Access Compliance Report Public Rights-of-Way (Pedestrian Signals)

Intersection ID: N/A	Main Street:	Cross Street: N/A	Location: N/A
ADA ID: BE04154DFAA5	Signal Type: One Push Button-Non APS	Overall Compliance: No	Severity Score: BTN 1: N/A BTN 2: N/A No BTN: N/A
Codes/Mitigation Info/Possible Solution		Field Measurements/Component Compliance

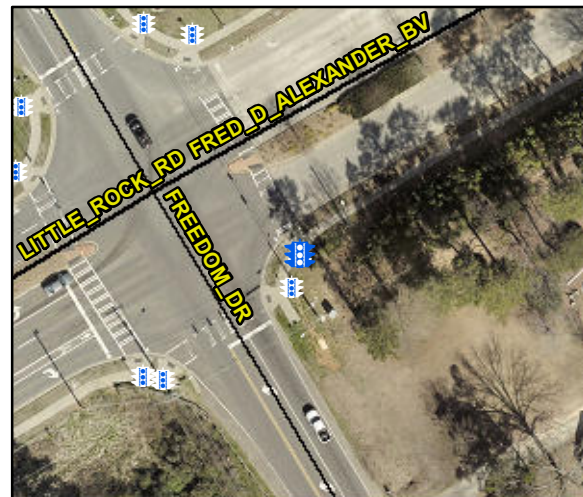
Possible Solutions: Replace Signal Push Button With APS Button on New Post. Remove & Relocate Sign.

N/A	B 1 Clear Xing Direction?	Yes	N/A	B 2 Clear Xing Direction?	N/A
	B 1 Crossing Direction	To NW		B 2 Crossing Direction	N/A
Yes	B 1 DistanceTo XWalk (in)	48.0	N/A	B 2 DistanceTo XWalk (in)	N/A
No	B 1 DistanceTo Curb (in)	132.0	N/A	B 2 DistanceTo Curb (in)	N/A
Yes	B 1 Diameter (in)	2.0	N/A	B 2 Diameter (in)	N/A
